Duke Power Company  
Oconee Nuclear Station

Attachment 1

Proposed Technical Specification Revision

#### Discussion of Proposed Technical Specification Revisions

Figure 6.1-2

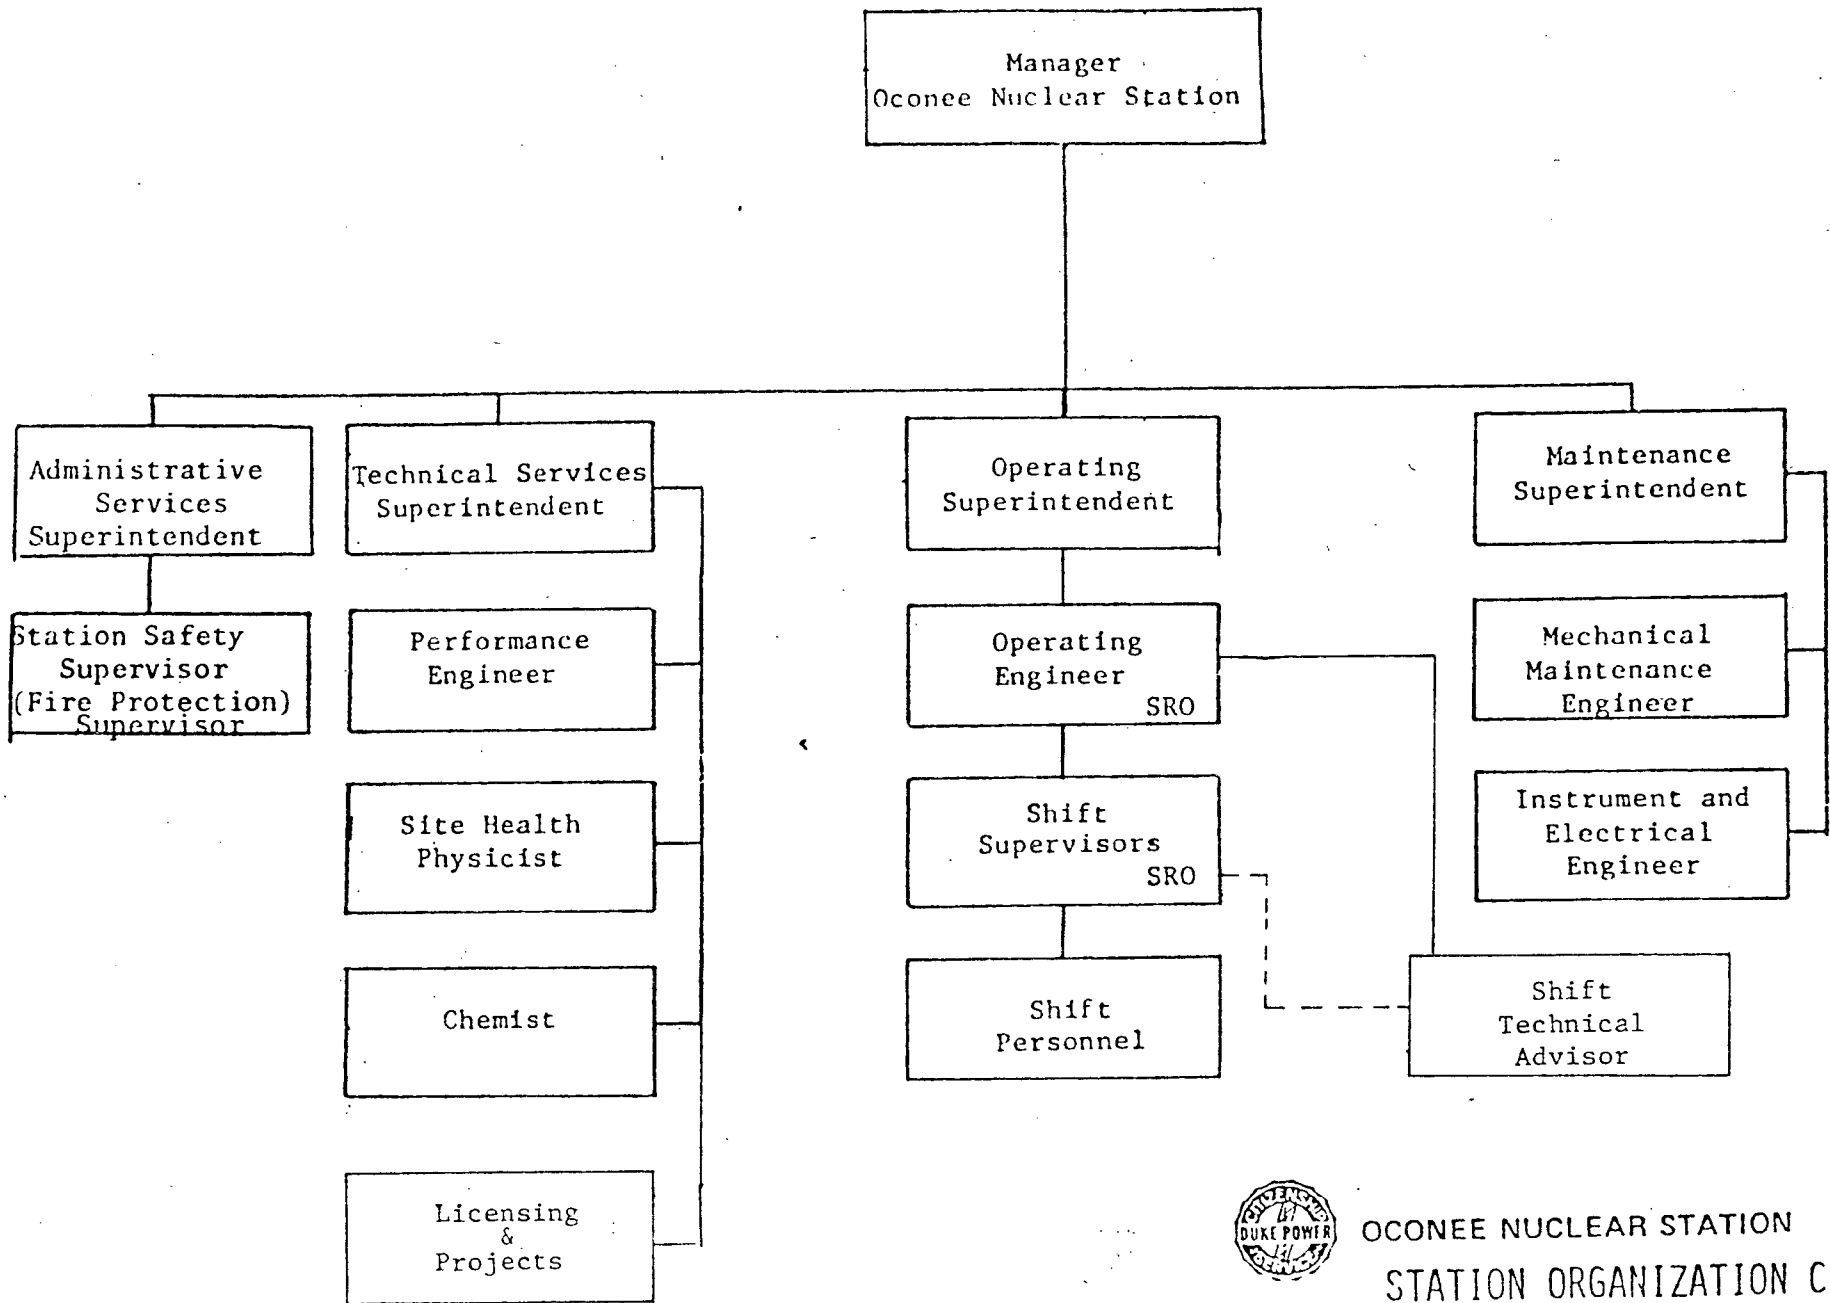
As of August 1, 1982 Duke Power Company will reorganize the Steam Production Department into three separate departments along functional lines: Nuclear Production Department, Fossil Production Department, and Production Support Department. The Nuclear Production Department will be organized as indicated in the diagram which is attached for your information. The changes proposed in the Technical Specifications mainly involve the title changes to be incorporated into the reorganization.

- 6.1.1.2 In all matters pertaining to actual operation and maintenance and to these Technical Specifications, the station Manager shall report to and be directly responsible to the Vice President, Nuclear Production Department, through the General Manager, Nuclear Stations. The organization is shown in Figure 6.1-2.

OCONEE NUCLEAR STATION  
STATION ORGANIZATION CHART  
FIGURE 6.1-1

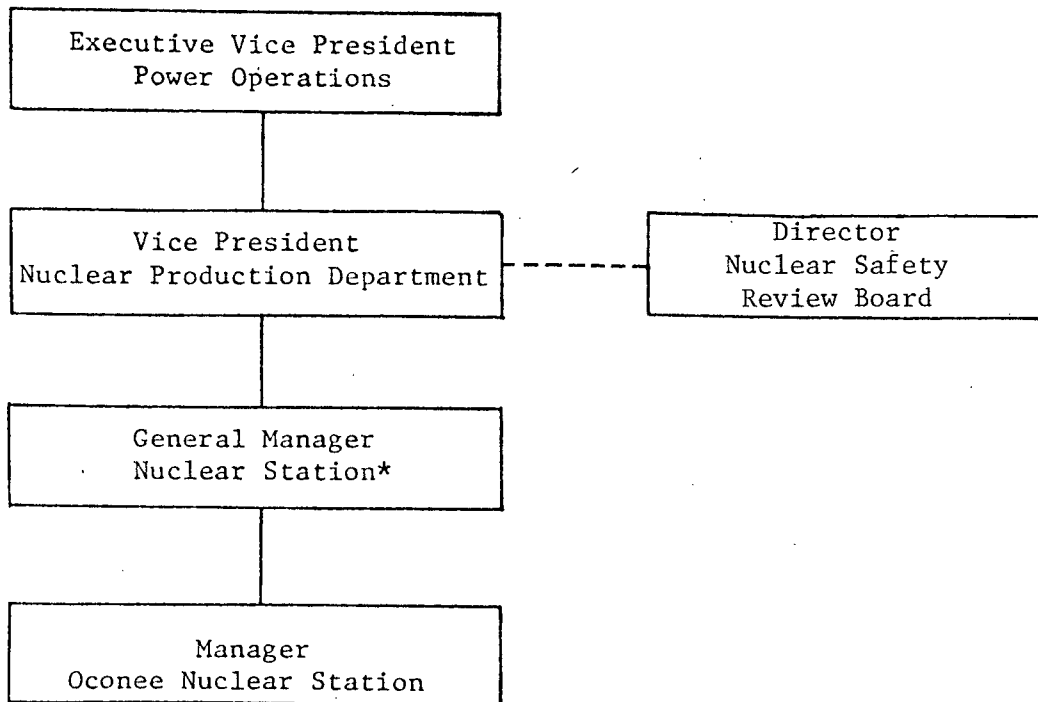
The organizational chain with plant operations has been revised in Figure 6.1-1. Under the proposed revision the Shift Supervisors report to an Operating Engineer. The Operating Engineers have the responsibility for directing the actual day-to-day operation of the units. The Operating Engineers report to the Superintendent of Operations who has the responsibility for operation of all Oconee Nuclear Station units. The requirement for the Superintendent of Operations to maintain a Senior Reactor Operator license has been deleted.

Within the multi-unit Oconee Nuclear Station, an Operating Engineer, as the direct supervisor of the Shift Supervisors, will have and maintain a Senior Reactor Operator license. However, the duties of the Superintendent of Operations do not require him to maintain a Senior Reactor Operator license, and the training required to maintain this license actually detracts from time that should be spent in managing the overall operations of the multi-unit Oconee Nuclear Station. This organization chart and the Senior Reactor Operator license requirements will be consistent with other Duke Power Company nuclear stations.

- 6.1.1.3 The station organization for Operations, Technical Services and Maintenance shall be functionally as shown in Figure 6.1-1. Minimum operating shift requirements are specified in Table 6.1-1.
